Broadcast Products Technical Bulletin 20-2006-212

DATE: **November 6, 2006**SUBJECT: **NO PICTURE**

MODEL: ***BVM-D14H1A***
BVM-D14H1E
BVM-D14H1U
BVM-D14H5A
BVM-D14H5E
BVM-D14H5U

Figure 1

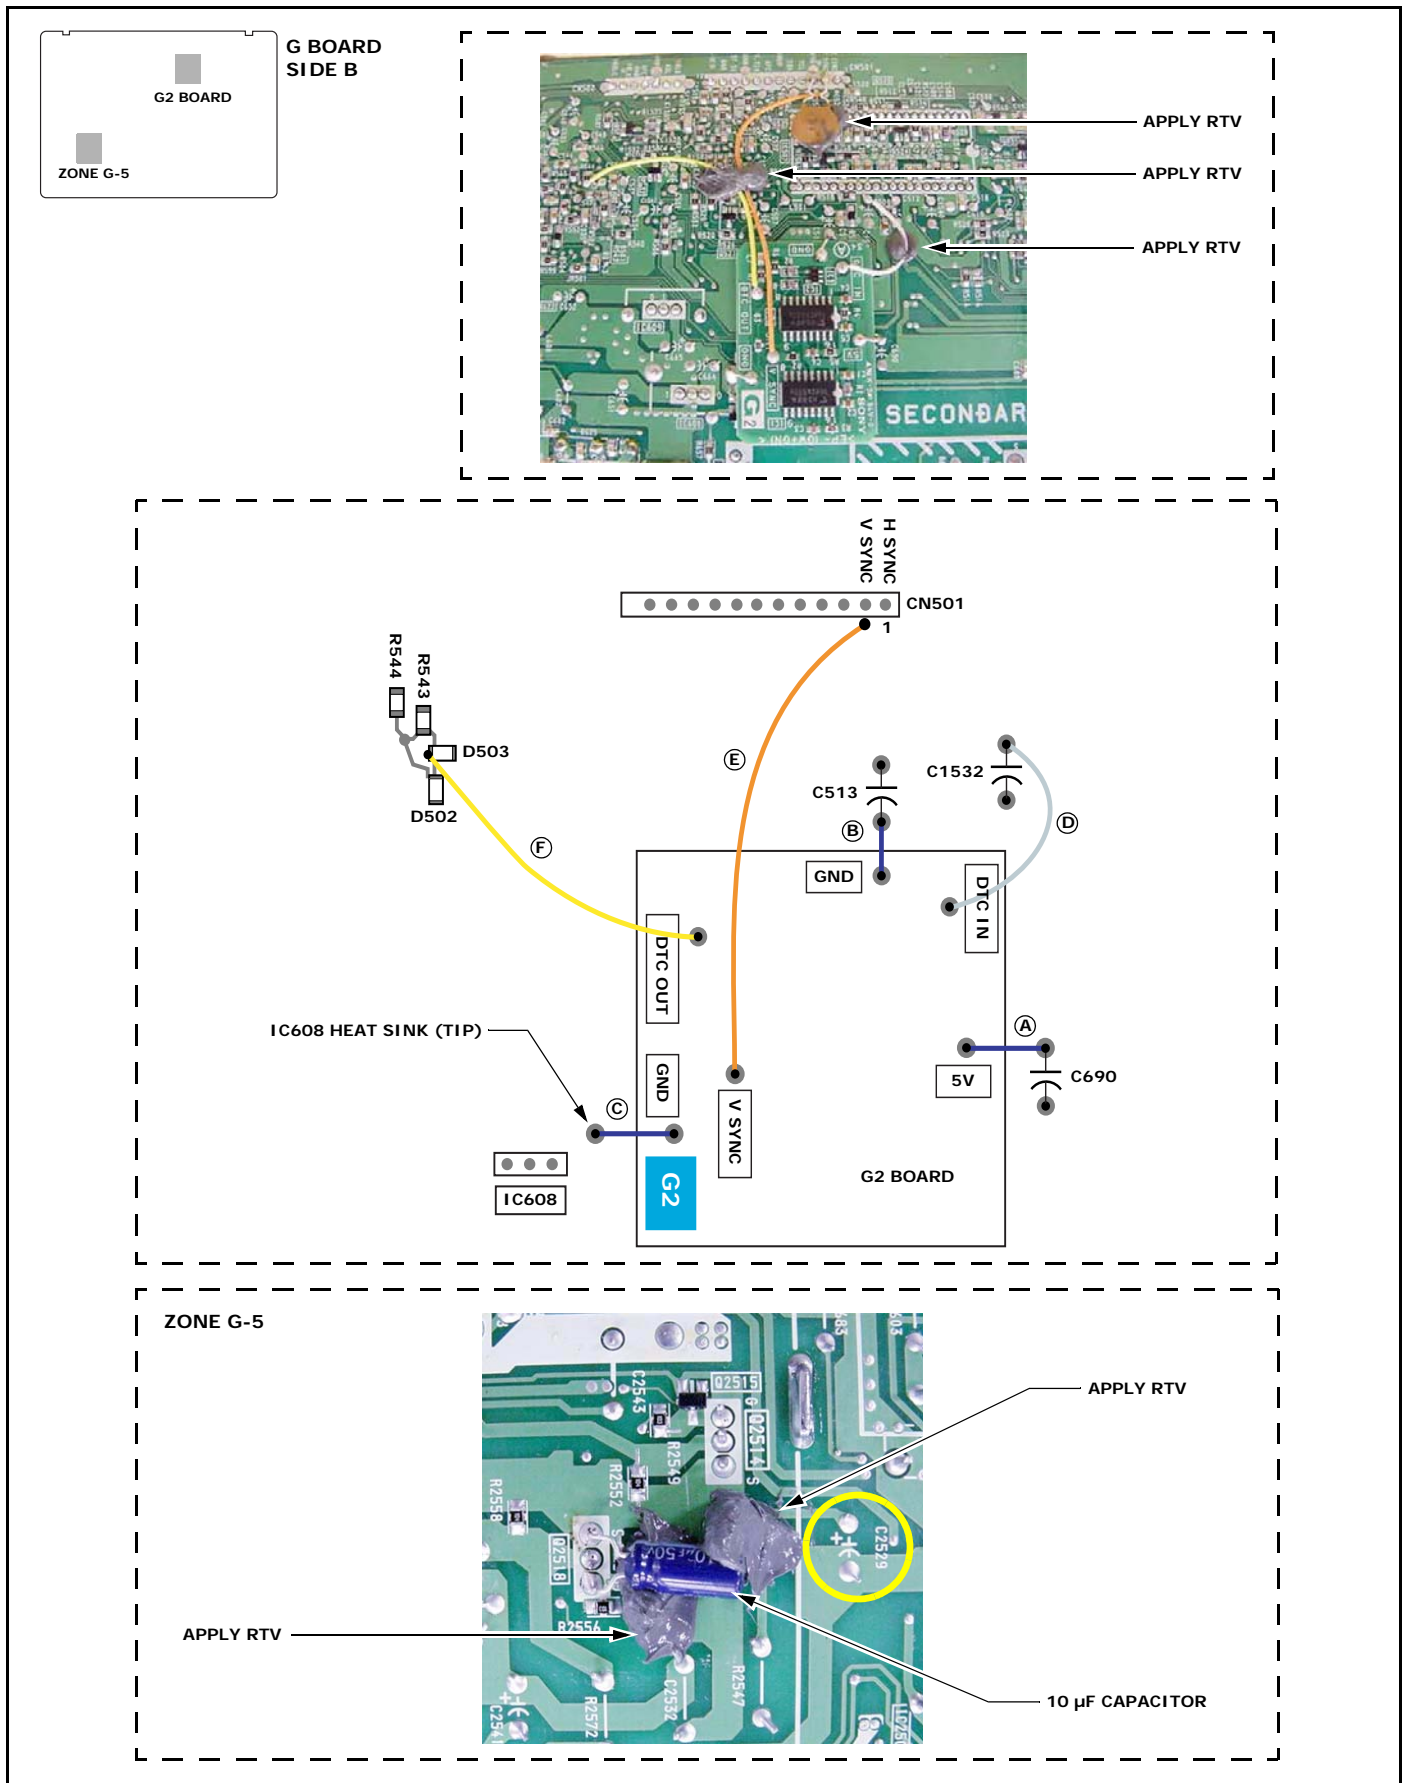
1. Replace Q2508 (H-OUT transistor, side A, zone J-7) with a new transistor.
2. Add the G2 piggyback board to the G board (side B) as follows:
 - a. Apply RTV to the rear of the G2 board.
NOTE: Apply an amount of RTV that will not ooze out from under the board when pressed.

- b. Position the G2 board on the G board so that the pairs of soldering points in step c are near to each other.
 - c. Solder tinned copper wire between:

G Board	G2 Board
(A) C690 (+)	DC 5V line
(B) C513 (-)	GND
(C) IC608 (tip)	GND

- d. Solder jumpers between:

G Board	G2 Board
(D) C1532 (+)	DTC IN (white)
(E) CN501 pin 2	V SYNC (orange)
(F) R543 (D503 side)	DTC OUT (yellow)

- e. Affix the jumpers to the G board with RTV.
3. Solder a 10 μ F capacitor between G-S of Q2518 (side B, zone G-5) with the negative (-) side of the capacitor connected to the source (S) of Q2518. (See Figure 1.)
4. Affix the capacitor to the board with RTV.
5. Replace C2529 (side A, zone G-5) with a 2.2 μ F capacitor.
NOTE: Refer to Technical Bulletin 20-2005-081R, which describes this capacitor.
6. If C1532 (side A, zone C-2) is 47 μ F/50V and R1574 (side B, zone C-1) is 10 k Ω :
 - a. Replace C1532 with a new 1 μ F capacitor, and
 - b. Replace R1574 with a new 100 k Ω resistor.If C1532 is 2.2 μ F/50V and R1574 is 100 k Ω , no further steps are necessary. The capacitor and resistor do not need to be replaced.
